**PUBLIC INTEREST REVIEW FOR GROUND WATER APPLICATIONS**

TO: Water Rights Section Date 02/07/2013  
 FROM: Ground Water/Hydrology Section K. Lite  
Reviewer's Name  
 SUBJECT: Application G- 17607 Supersedes review of \_\_\_\_\_  
Date of Review(s)

A. **GENERAL INFORMATION:** Applicant's Name: Gutierrez Cattle Co. County: Crook

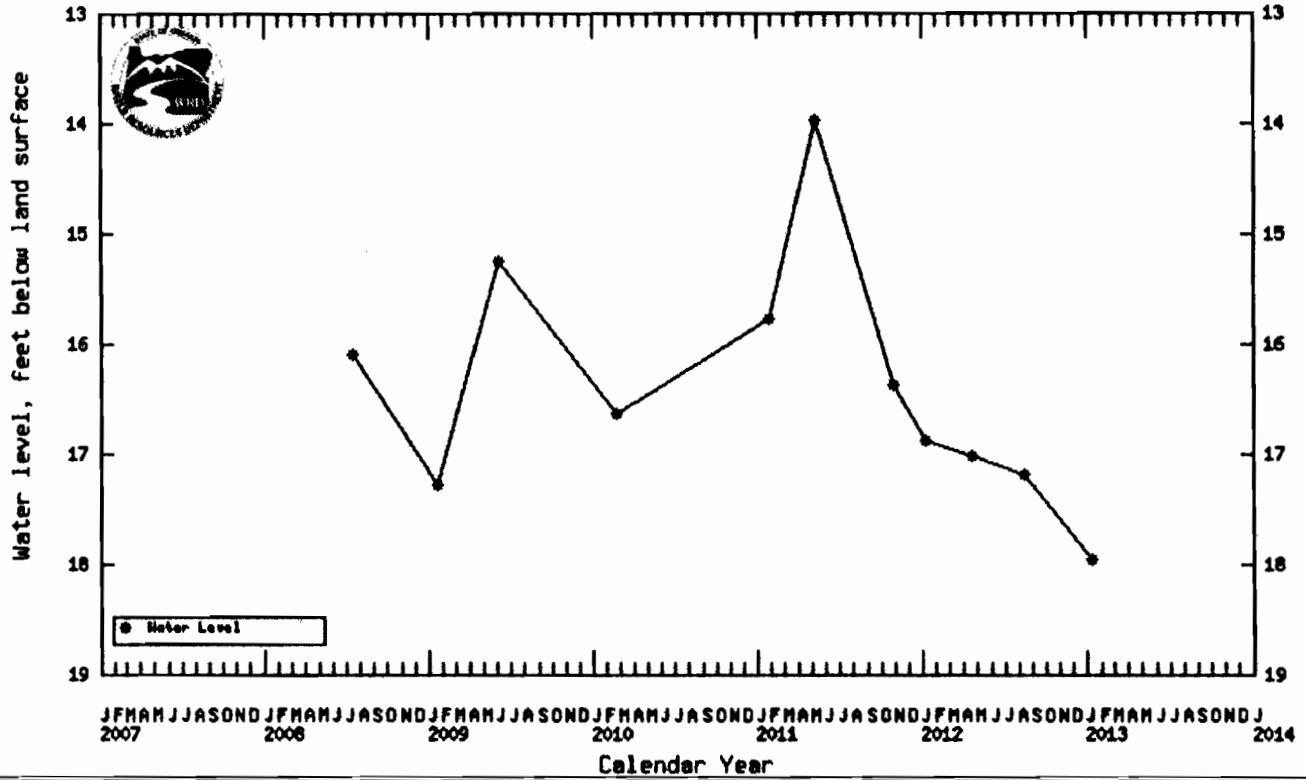
The nearest OWRD observation well is CROO 53416, about 2.8-4.6 miles south of the well sites. It has been monitored periodically since 2008. The observation well appears to generally fluctuate about 1-2-feet per year and has declined about 1- foot per year during the period of record.
